Subject: Duke Energy Carolinas, LLC
William States Lee III Nuclear Station – Docket Nos. 52-018 and 52-019
AP1000 Combined License Application for the
William States Lee III Nuclear Station Units 1 and 2
Supplemental Response to Request for Additional Information
Ltr# WLG2012.06-10

Lee Nuclear Station Supplemental Response to Request for Additional Information (RAI)

Reference NRC RAI Number(s): 10.04.05-002

4) COLA Part 2, FSAR Figure 2.4.2-202 is revised as shown:

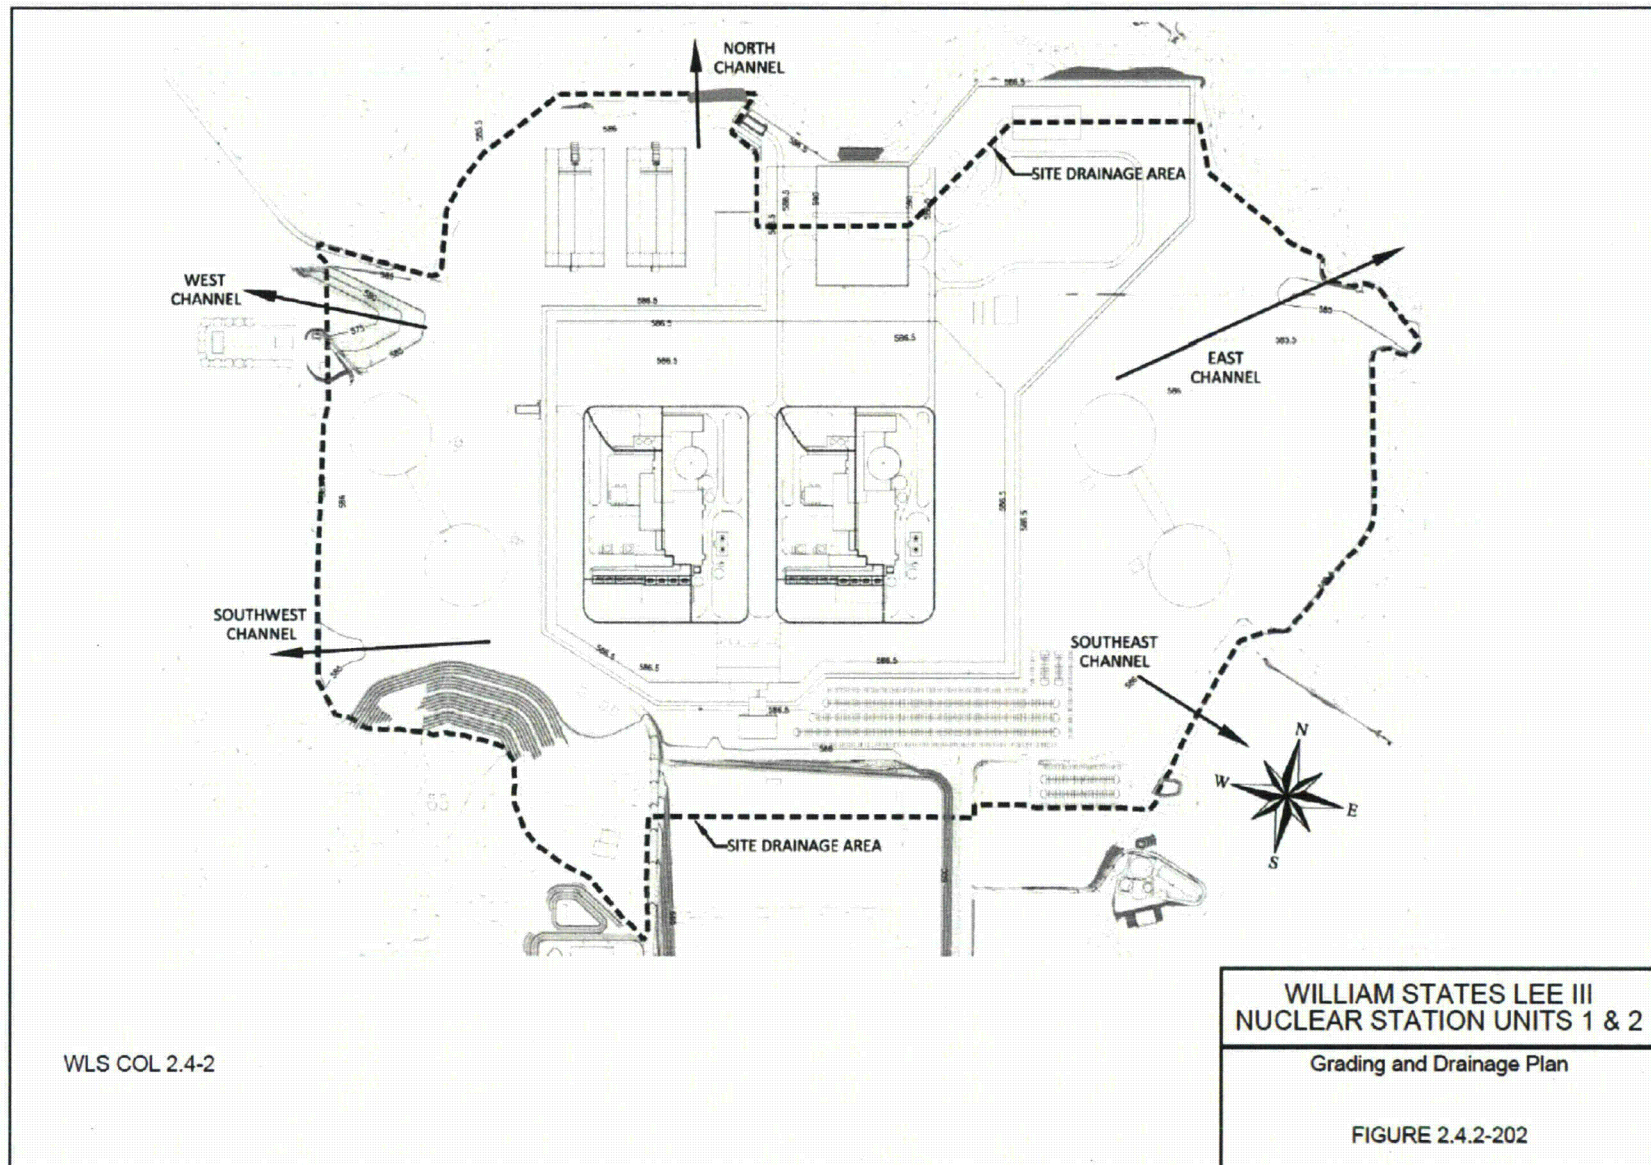
Analysis of the Effects of Local Intense Precipitation (Local Site PMP Event) The site grading and drainage plan is illustrated in revised FSAR Figure 2.4.2-202 (see Attachment 3). The revised plan provides additional improvement to overall site drainage via the following changes:

- The southwest channel is widened, providing for increased drainage toward MUPB.
- A berm located in the southeast area of site, near Make-Up Pond A (MUPA), is removed, providing the channel on the southeast side of the site (i.e., the "southeast channel").
- The perimeter roadway around the Unit 1 and Unit 2 power blocks is graded to provide a smooth transition, having the impact of removing a weir-effect at the road and allowing the modeling of this area as open channel flow.

Portions of the site are relatively flat; however, the site is graded such that ~~overall~~ runoff will drain away from safety-related structures either to Make-Up Pond B, Make-Up Pond A, or directly to the Broad River through five grass covered drainage channels. These channels, illustrated in Figure 2.4.2-202, are assumed to be the only flow paths for runoff from the site and establish the downstream boundary conditions for site runoff for modeling purposes. Runoff from a specific power block area flows through four graded channels per unit as described in the discussion below and then through the five site discharge channels to the receiving water body. ~~The PMP flood analysis assumes that all discharge structures are non-functioning.~~ Computed water surface elevations in the vicinity of safety-related structures are below plant elevation of 590 ft. The site grading and drainage plan is shown in [Figure 2.4.2-202](#).

Cross sections for each of the five~~three~~ discharge channels are determined based on the site grading and drainage plan (Figure 2.4.2-202). Site structures are modeled to obstruct flow and are assumed to provide no storage. A Manning's roughness coefficient of $n = 0.050$ is used for all cross sections in the reservoir model, which bounds the ground cover used for site conditions (i.e., grass lined channels and/or paved-gravel areas). HEC-RAS modeling was performed using steady state analysis to establish an elevation-discharge relationship at the upstream cross section. The results for the five discharge~~three~~ channels are combined with the elevation-storage relationship to establish a complete elevation-discharge-storage relationship for the idealized reservoir.

5) COLA Part 2, FSAR Figure 2.4.2-204 is revised as shown:

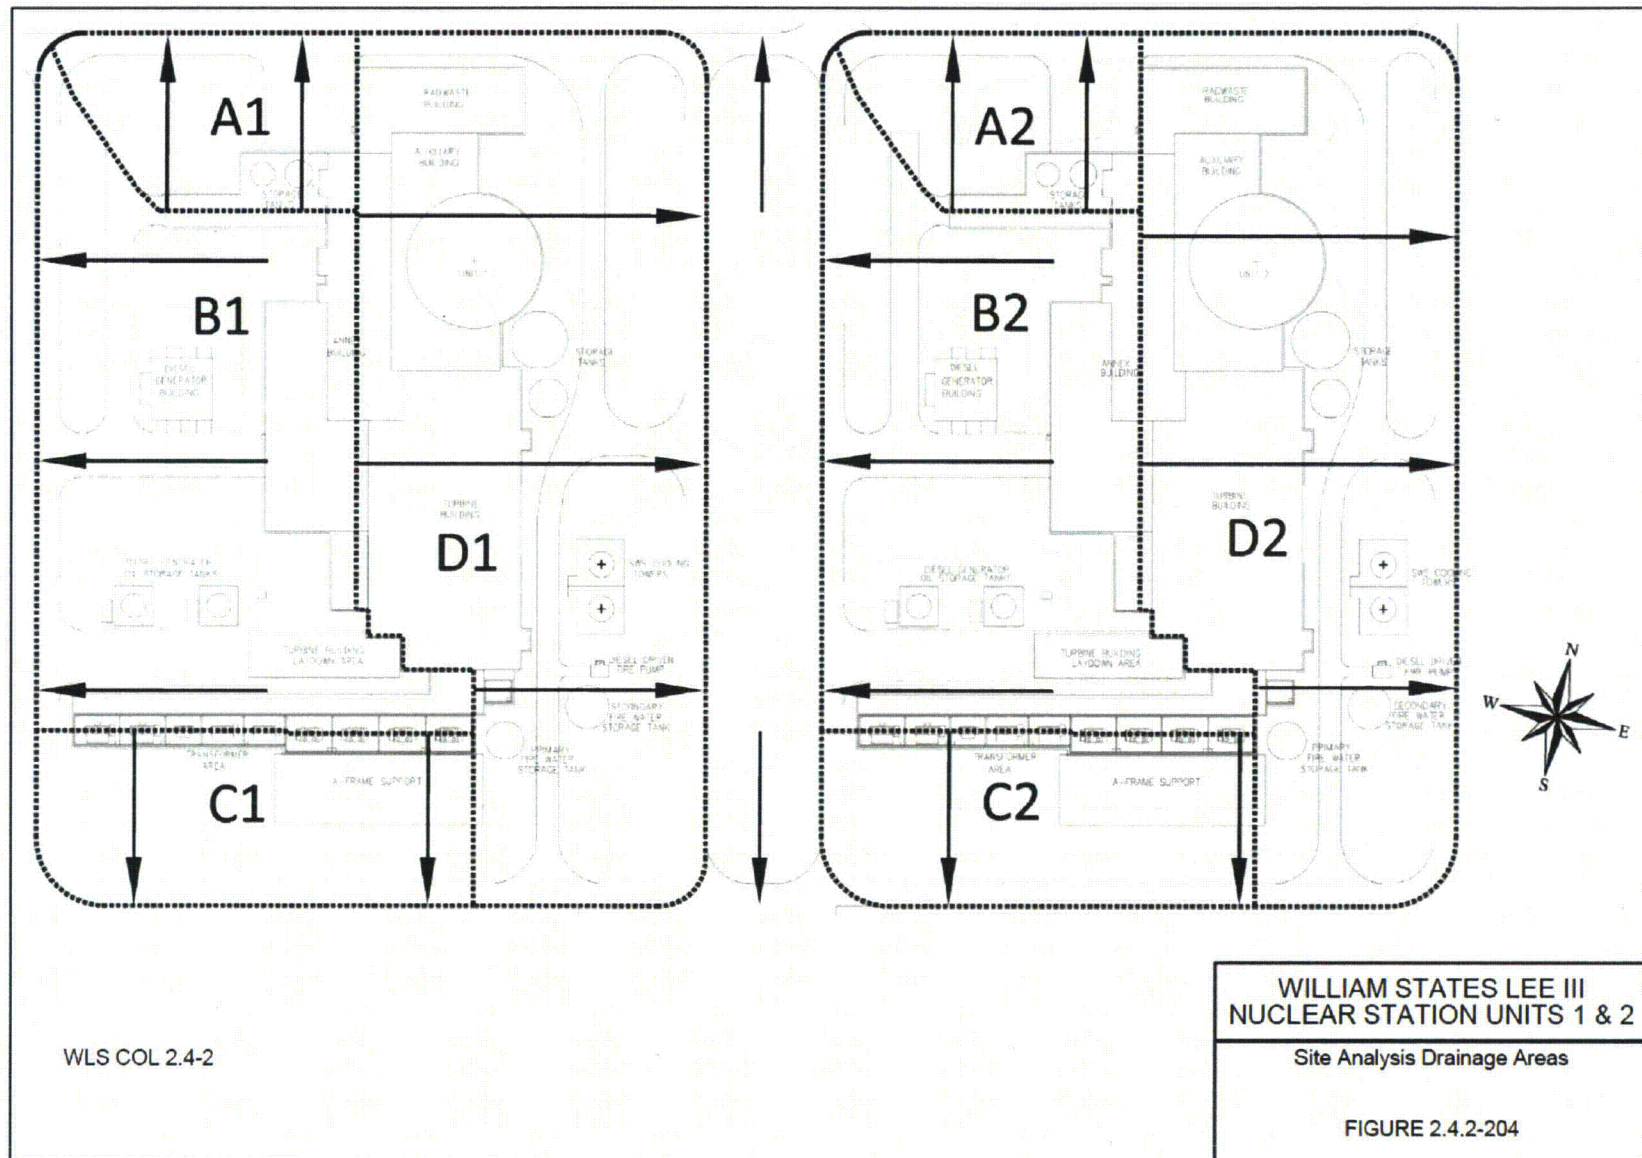
For modeling purposes each unit's power block is divided into four drainage areas. The modified model design reflects the current site grading and drainage plan. The power block specific drainage areas are illustrated in revised FSAR Figure 2.4.2-204 (see Attachment 3).

As shown in [Figure 2.4.2-204](#), runoff is directed away from the [power block](#) units to lower lying areas [via four discharge channels](#). Under the assumption that all subsurface drainage features are non-functional, runoff would [overtop-flow over](#) roadways or other topographical features as the flow exits the areas immediately adjacent to the [power block](#) units.

For each [power block](#) area shown in [Figure 2.4.2-204](#), the peak runoff is determined using the maximum PMP intensity of 6.2 in/5 min from [Table 2.4.2-203](#). The peak runoff is determined by multiplying the drainage area by the intensity and converting the units to cubic feet per second. This approach is essentially equivalent to the Rational Method using a runoff

The power block drainage areas, shown in Figure 2.4.2-204, are evaluated using the maximum water surface elevation for the idealized reservoir as the downstream boundary condition. Therefore, the HEC-HMS modeling for the idealized reservoir becomes the downstream boundary condition for the power block areas' channel flow evaluation. The four discharge channels for the Unit 1 power block area and the four discharge channels for the Unit 2 power block area are evaluated by steady state, open channel flow, backwater analysis, modeled using HEC-RAS version 4.1.0 software.

10) COLA Part 2, FSAR Figure 2.4.3-201 is revised as shown:

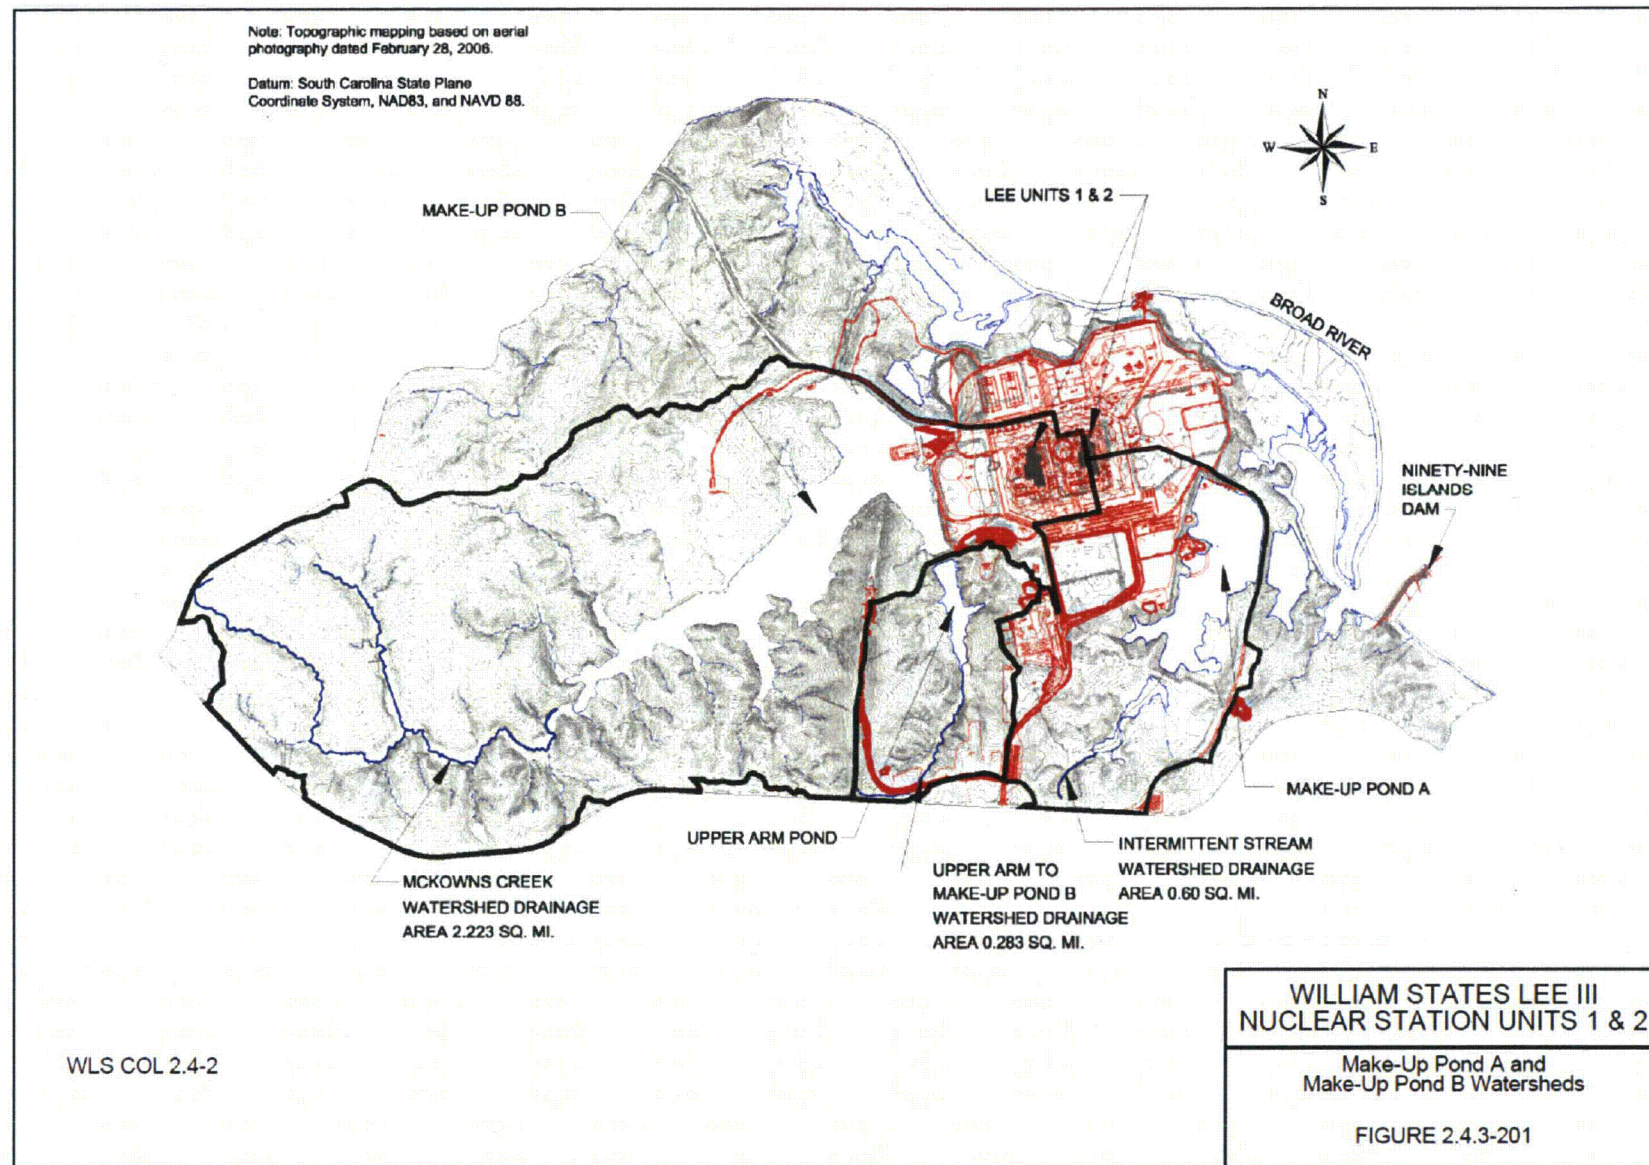
The PMF for McKowns Creek and Make-Up Pond B is determined from the PMP for the 2.23355-sq. mi. drainage basin of Make-Up Pond B and the 0.283 sq. mi drainage basin of the Upper Arm. ~~The~~ Make-Up Pond B drainage basin, including the Upper Arm, is shown in Figure 2.4.3-201.

For McKowns Creek/Make-Up Pond B and the Upper Arm, HEC-HMS modeling software was used for rainfall runoff and storage routing calculations. The watershed is shown in Figure 2.4.3-201. Methods adopted to account for nonlinear basin response at high rainfall rates include increasing the peak of the unit hydrograph by 20 percent and reducing the time to peak by approximately 33 percent. Topographic characteristics of the site and watershed are described in Subsection 2.4.1.2.1.

18) COLA Part 2, FSAR Figure 2.4.3-246 is added as follows:

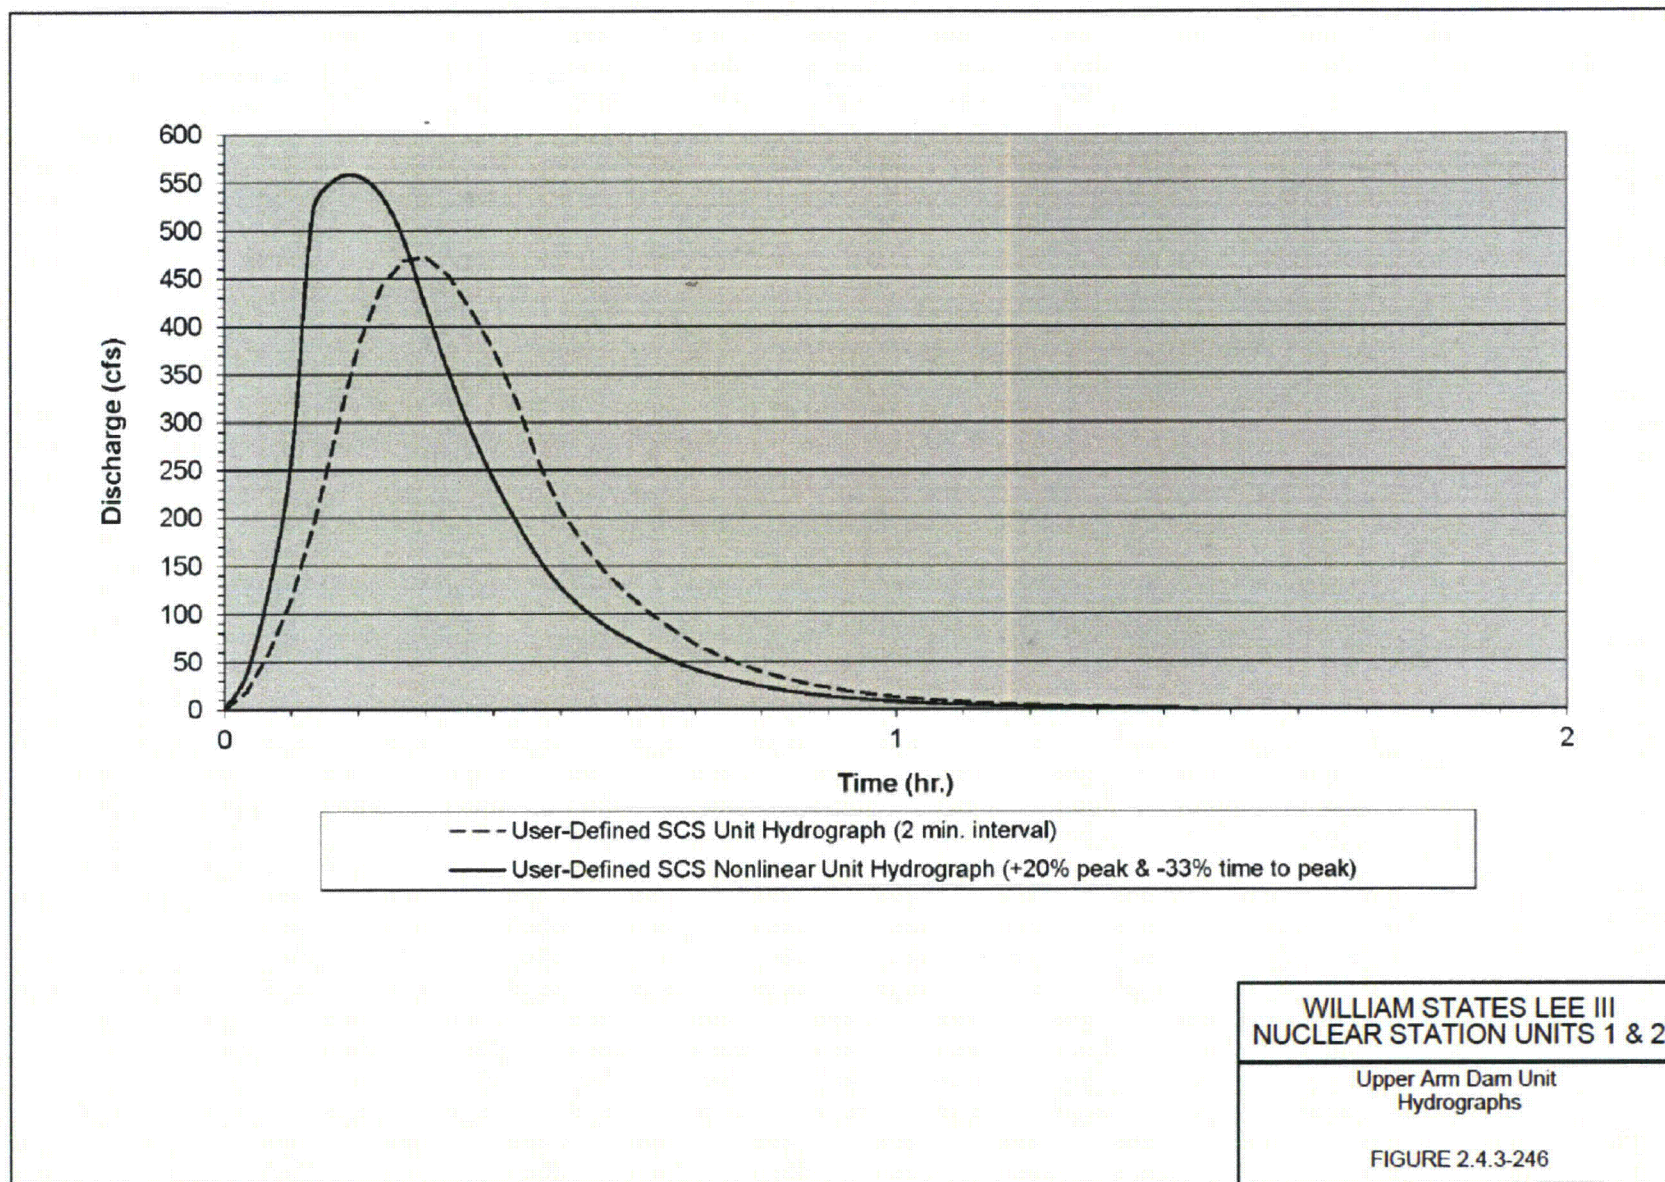
The best calibration of the modified SCS unit hydrograph with the initial SCS unit hydrograph was found using a 2-min. computational time step in the Upper Arm watershed in the HEC-HMS modeling software. Therefore, the time step used to define the ordinates of the modified SCS unit hydrograph is also 2 min. The Upper Arm subbasin has a lag time of 16 min. The initial SCS unit hydrograph and modified unit hydrograph to account for the effects of nonlinear basin response are provided in Figure 2.4.3-246. The modified SCS unit hydrograph is tabulated in Table 2.4.3-209.

19) COLA Part 2, FSAR Figure 2.4.3-247 is added as follows:

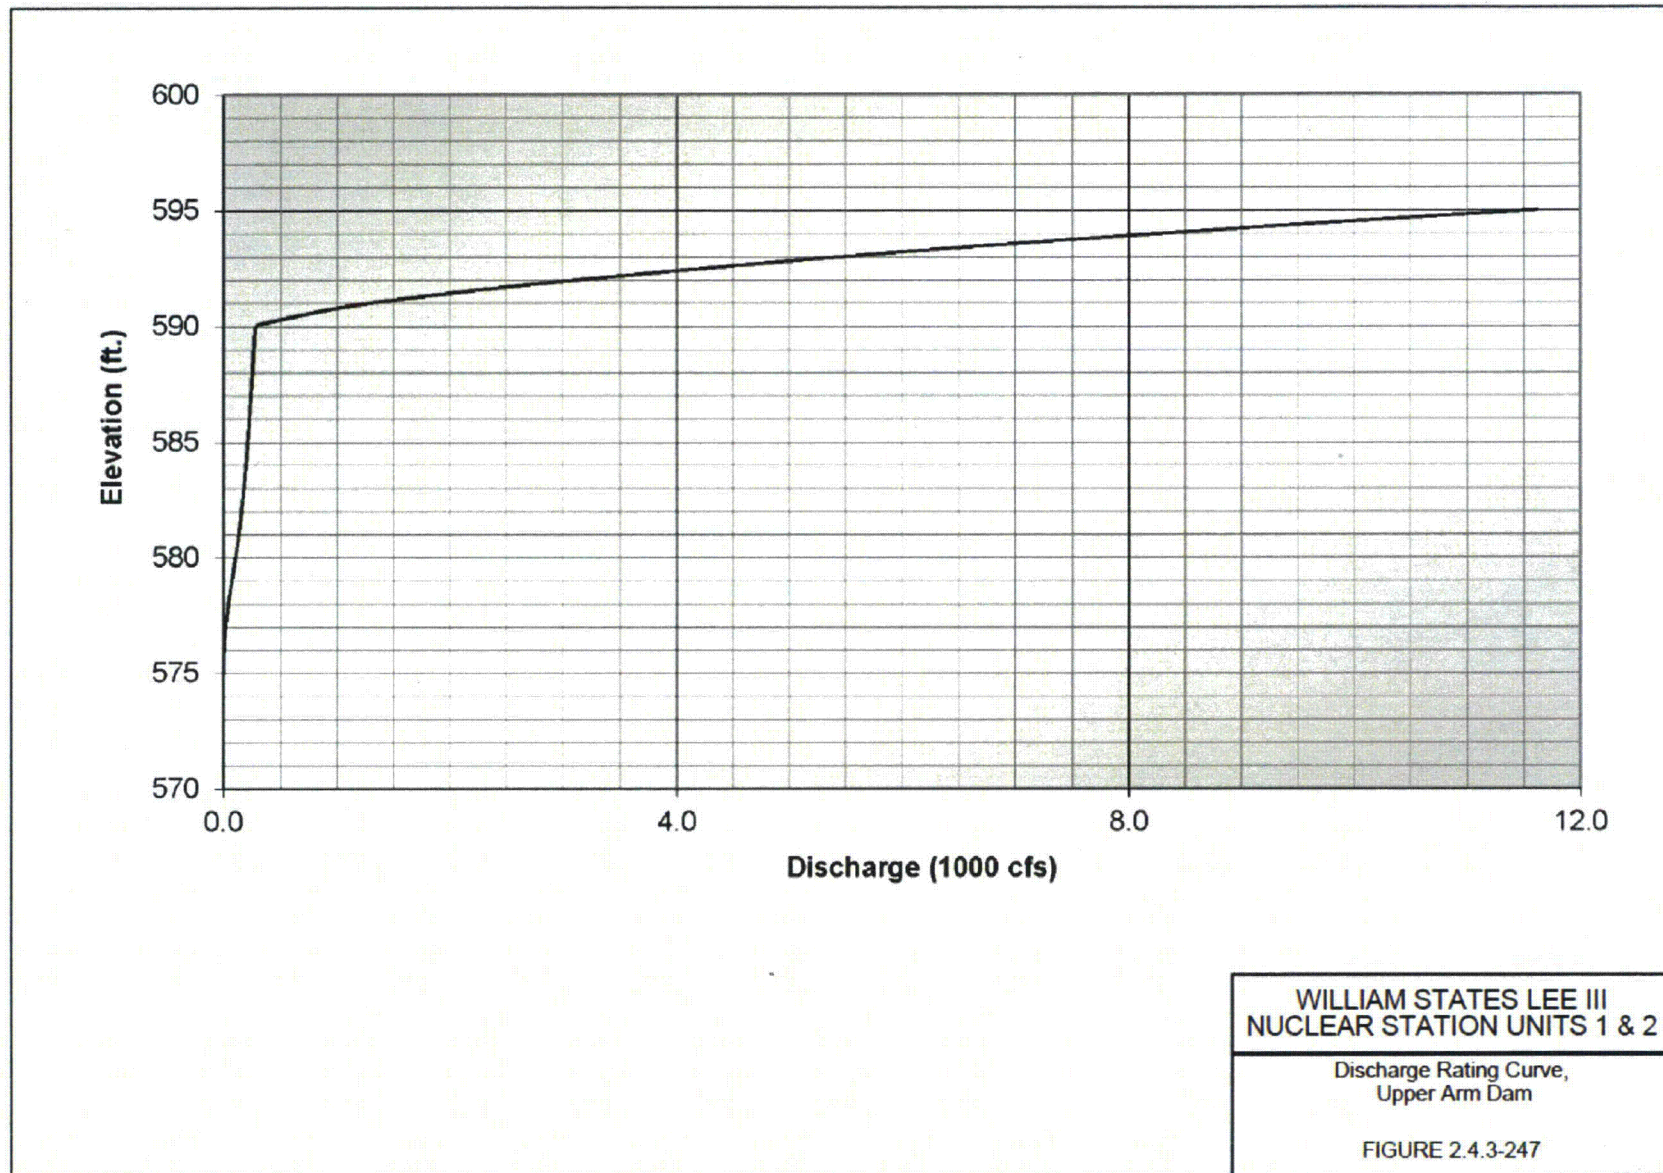
2.4.3-247 and is presented as a combination of culvert flow and weir flow. Available storage was determined based on aerial topography. Figure 2.4.3-248 provides the storage capacity curve. Antecedent conditions for the normal full pond elevation were assumed to be 575.4 ft. based on historical observation.
